ADDENDUM NO. 2

NIKE, INC.

NIKE RETAIL

LENOX SQUARE MALL - ATLANTA, GA

1 LEVEL 01 - HVAC PLAN
3/16" = 1'-0"

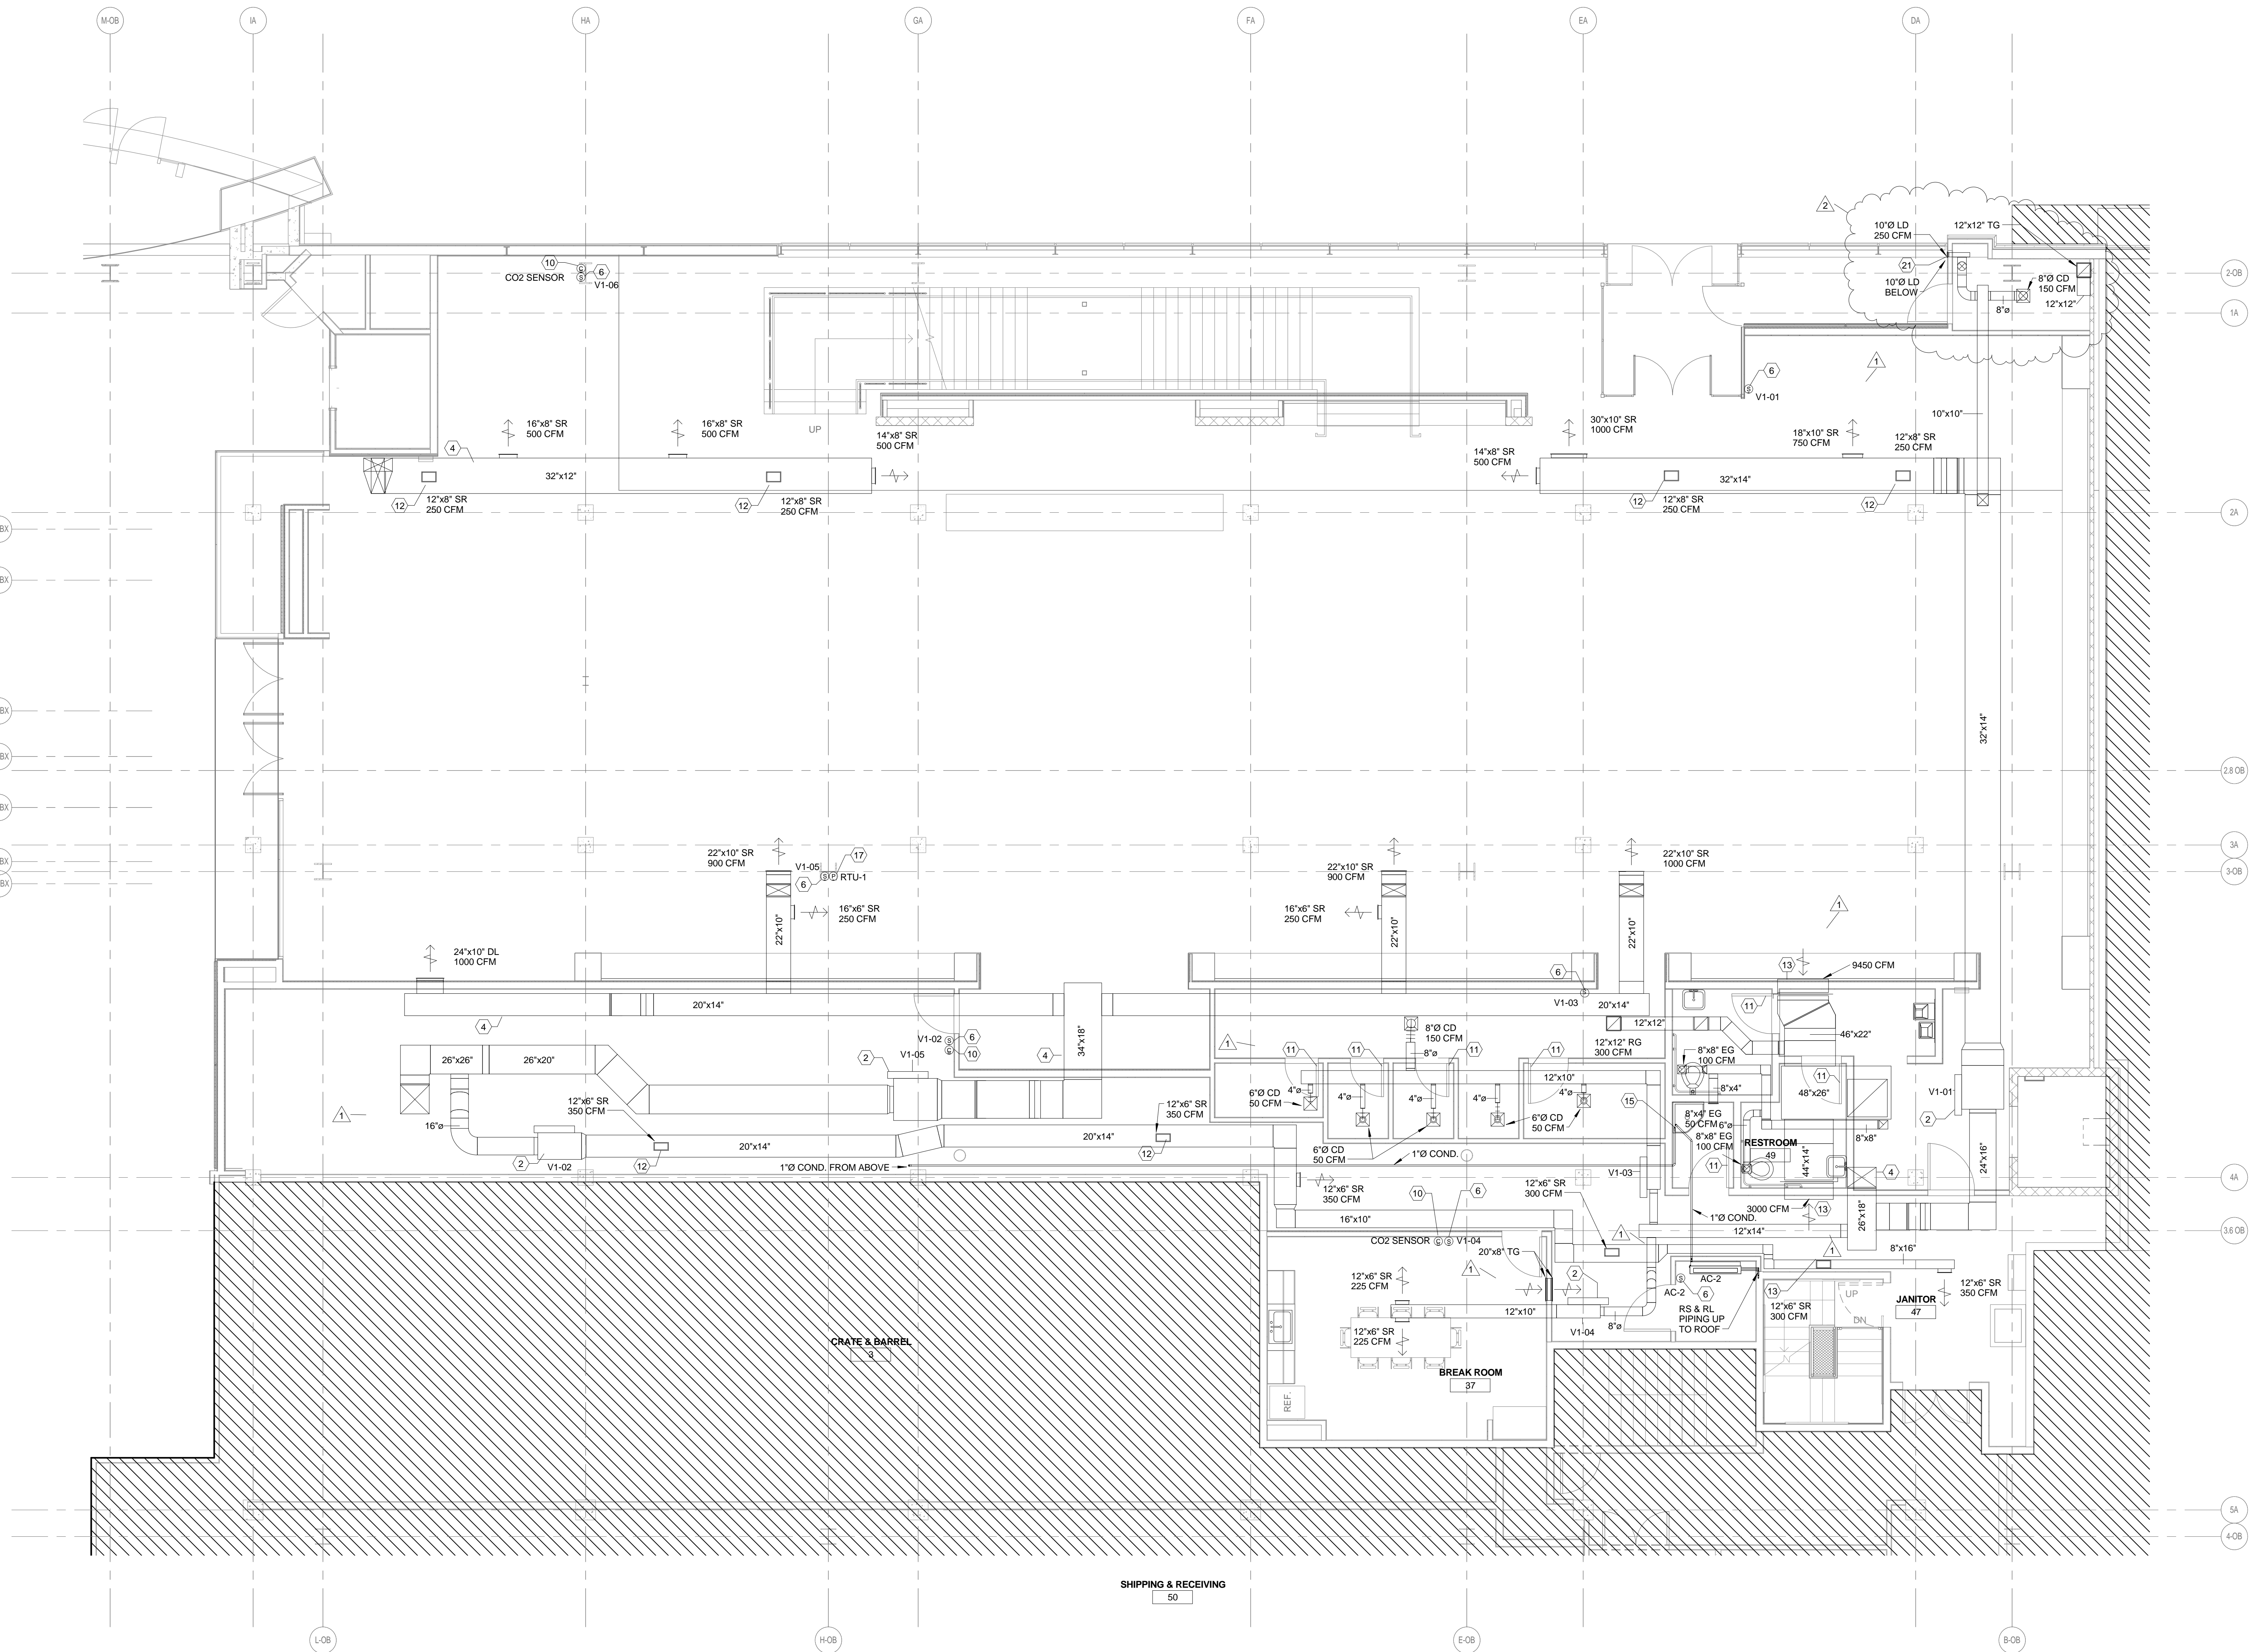
1.15 M2.01
Add: Revised linear diffusers serving display area. Tag note 21 was added for clarification.

M2.03

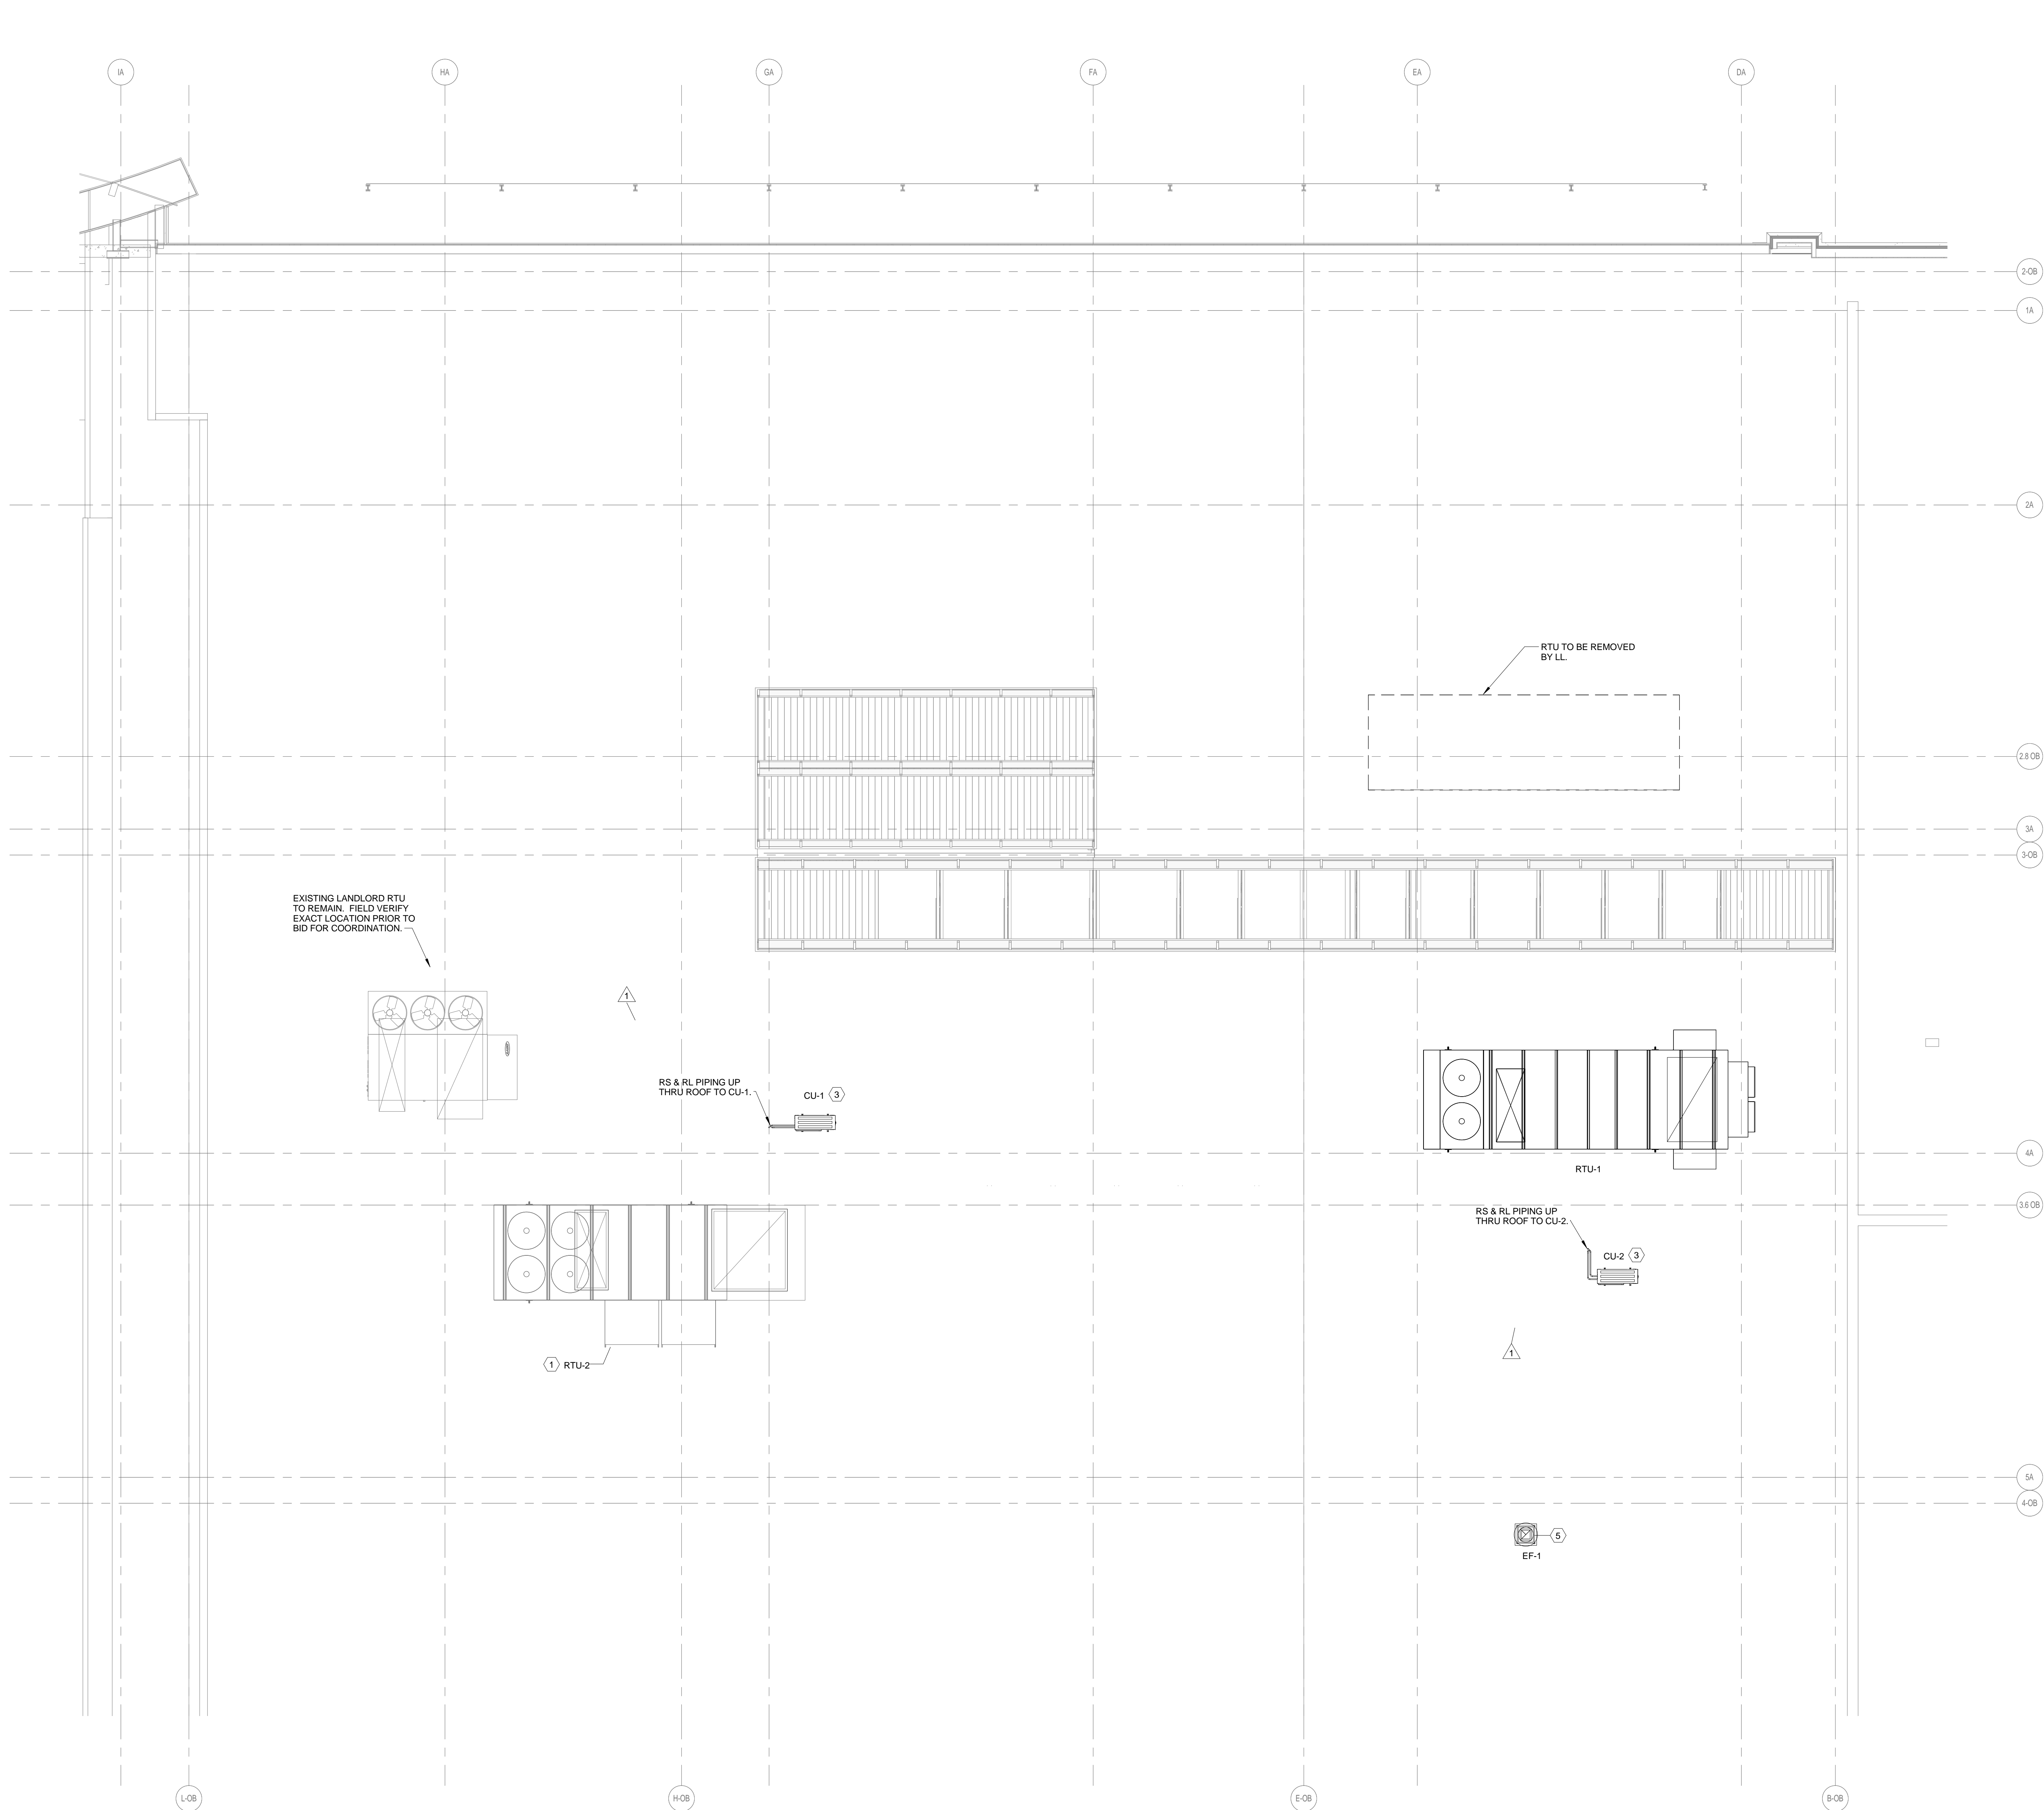
1.16 M2.03:
Clarification: Note 3 was modified to include landlord required note, pitch pockets and wood blocking not permitted.
Clarification: Note 1 was modified to direct the mechanical contractor to install the CSUSA furnished outside air monitoring station.

P2.01

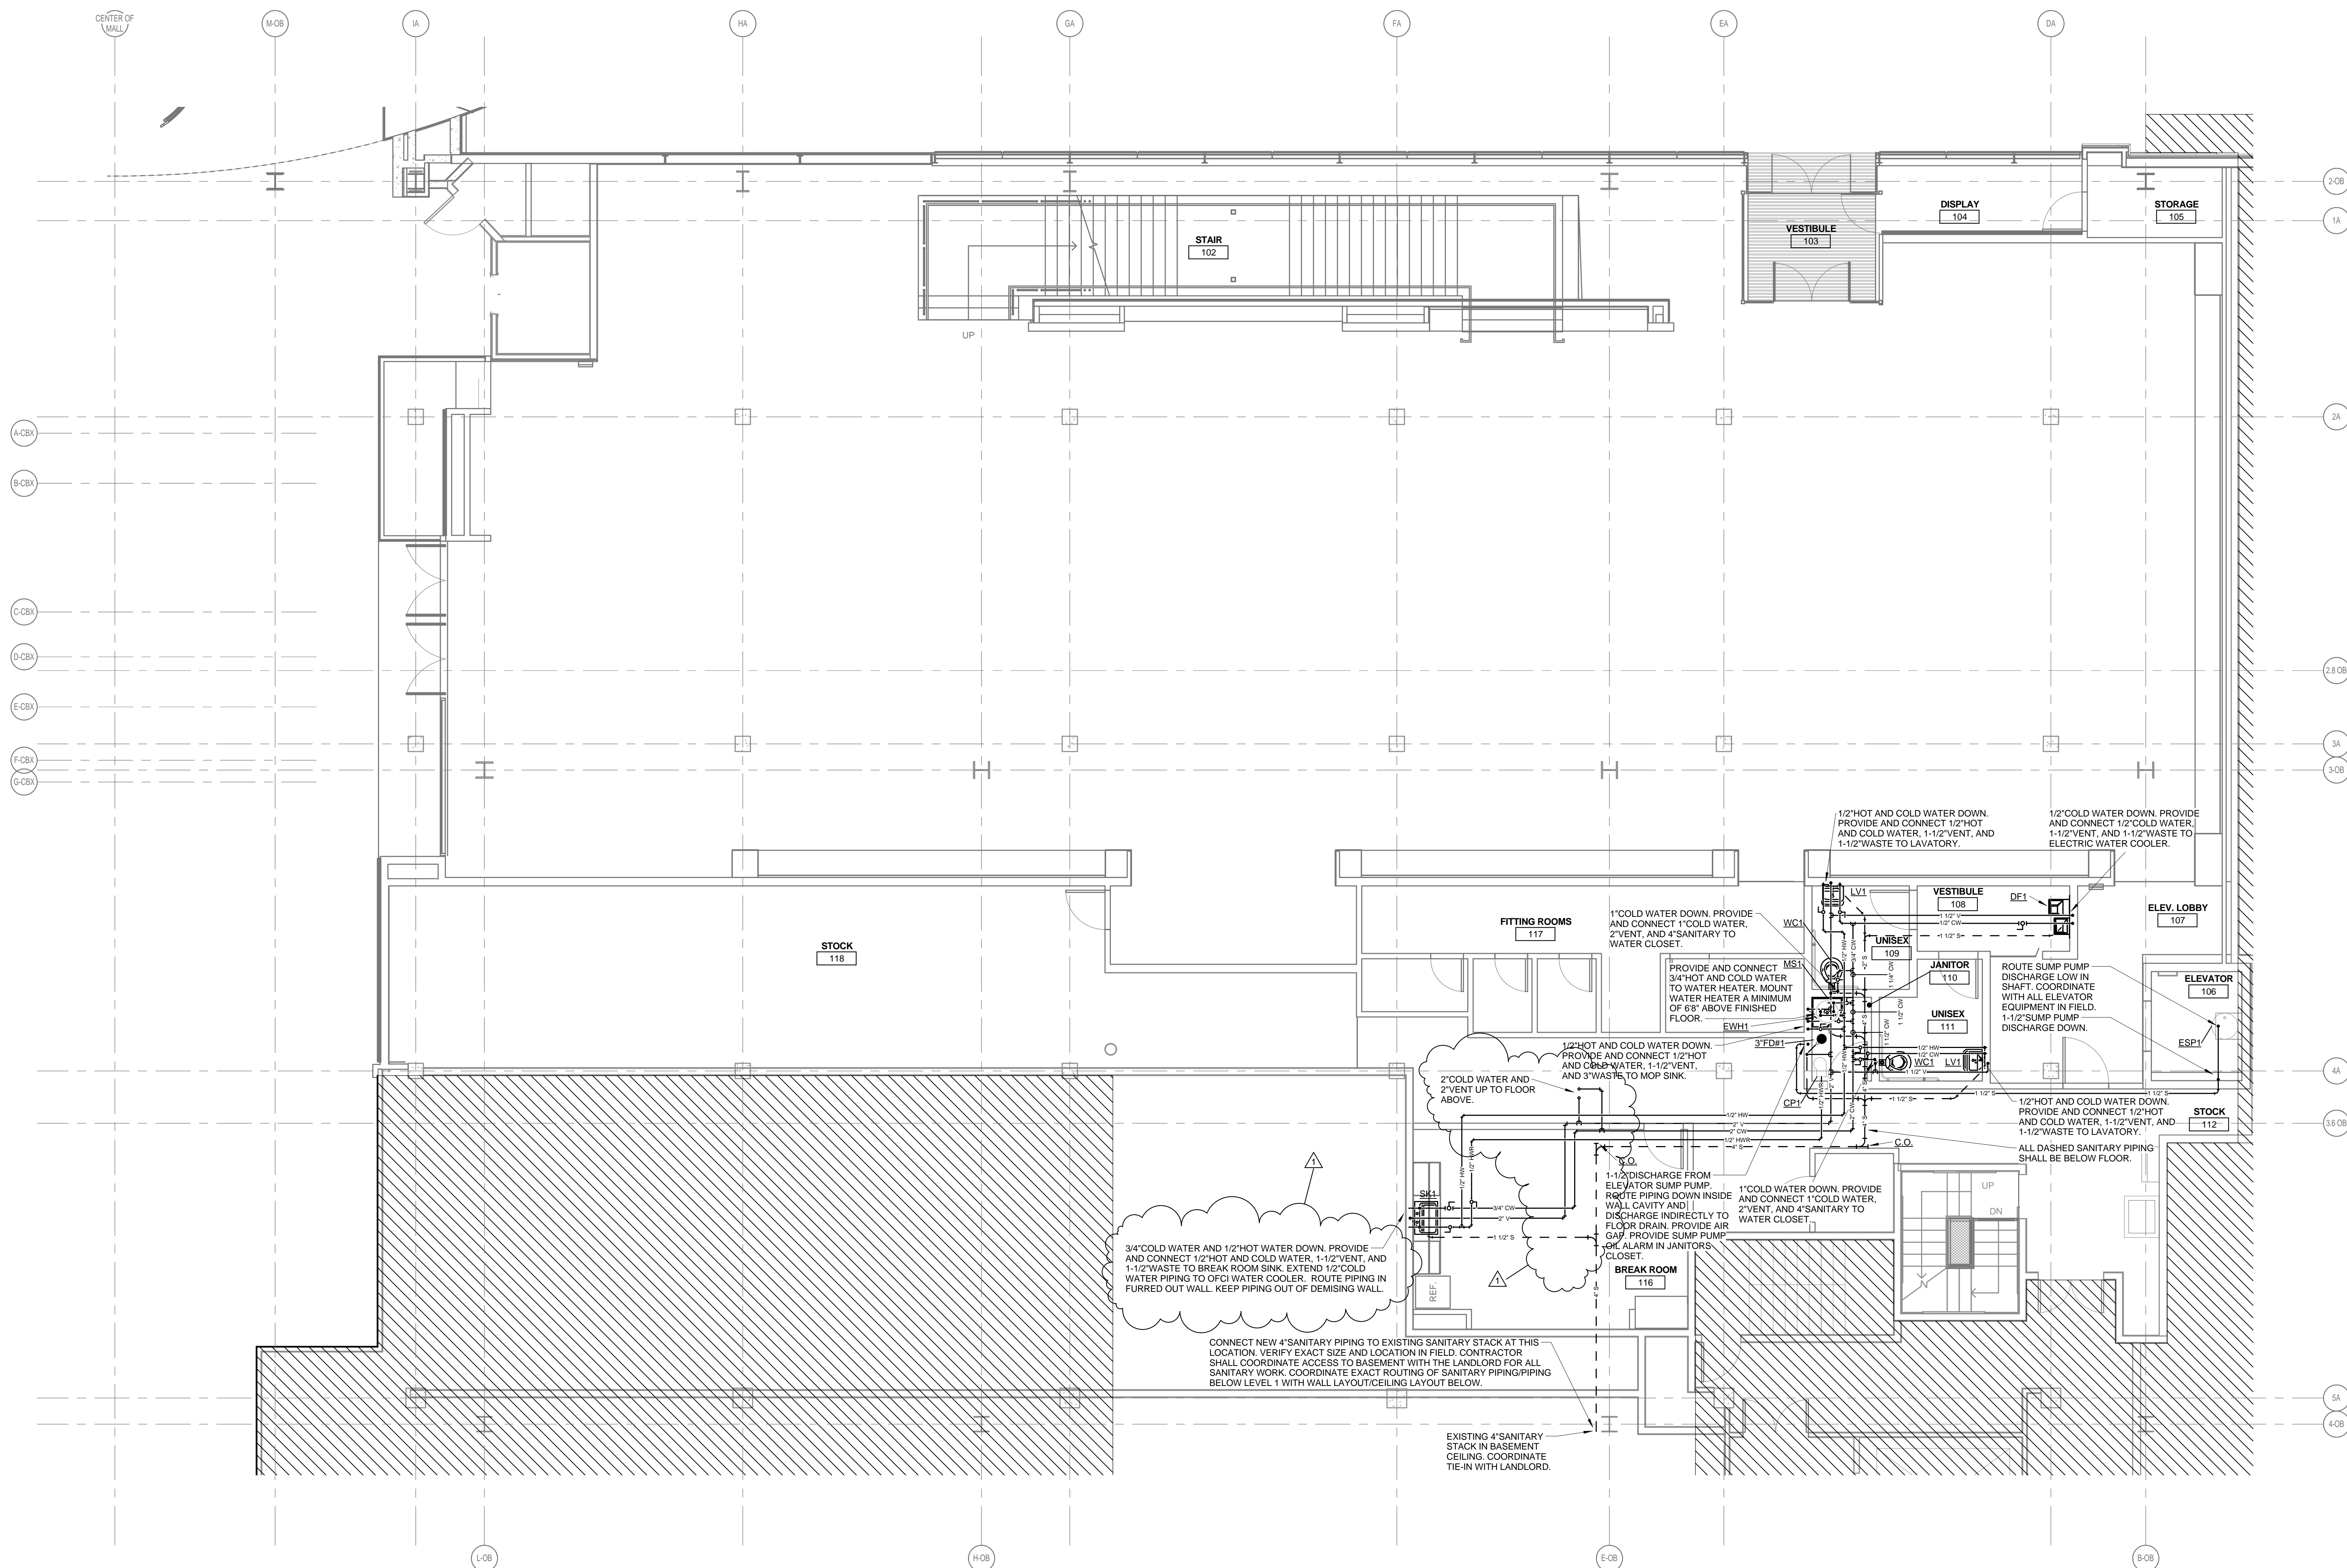
1.21 P2.01
Add: Added note to route sink piping in furred out wall.

Revised: Revised location of Cold water and Vent stack to second floor.
